1968 Corvette: Service Bulletin: Heat Damage to Engine Wiring Harness at Starter Solenoid

Model and Year: 1968 Corvette with 396 or 427 Cubic Inch Engine

Bulletin No: 68-T-66

Date: October 30, 1968

Figure 1

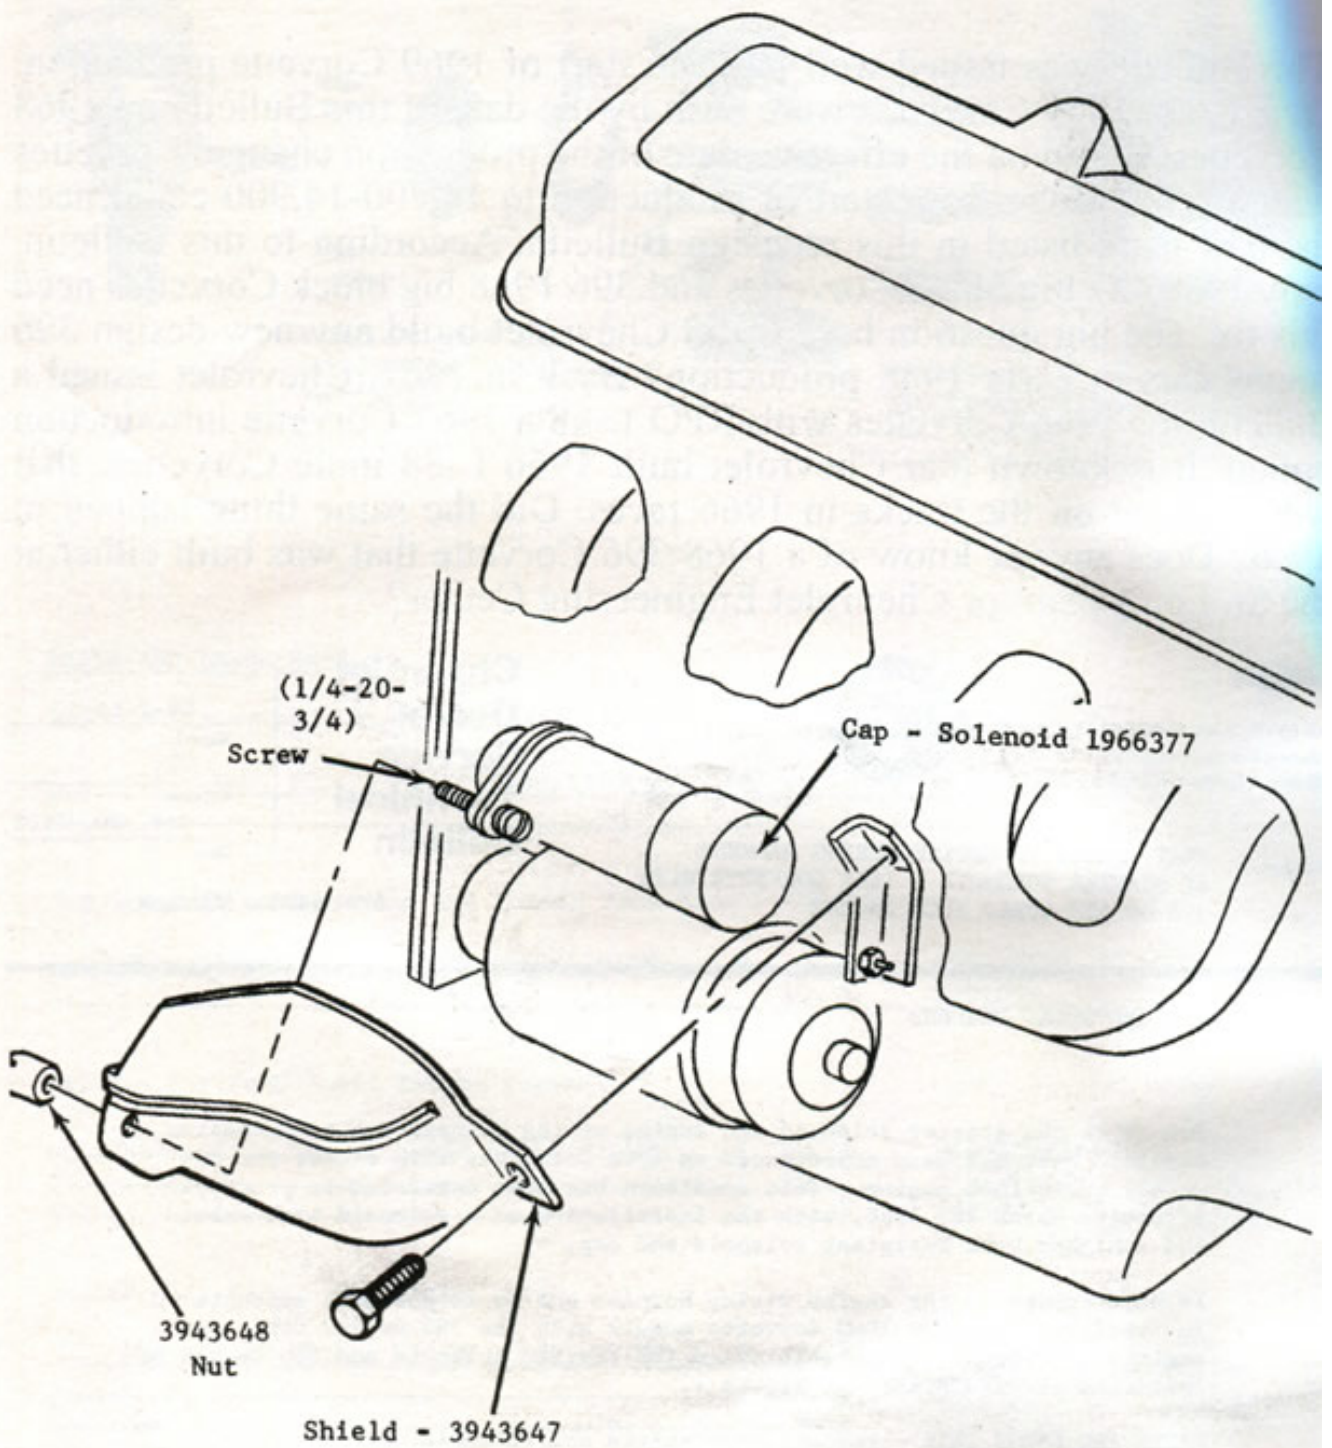
Damage to the starter solenoid and engine wiring harness due to excessive manifold heat has been experienced on 1968 Corvettes with either the 396 or 427 cubic inch engine. This condition has been corrected in production effective March 28, 1968, with the installation of a solenoid heat shield and a higher heat resistant solenoid end cap.

If heat damage to the engine wiring harness and/or solenoid is encountered in the field on early 1968 Corvette models with the 396 or 427 cubic inch engine, the solenoid heat shield and the revised solenoid end cap should be installed as illustrated in figure 1.

Installation of Heat Shield
and Solenoid Cap
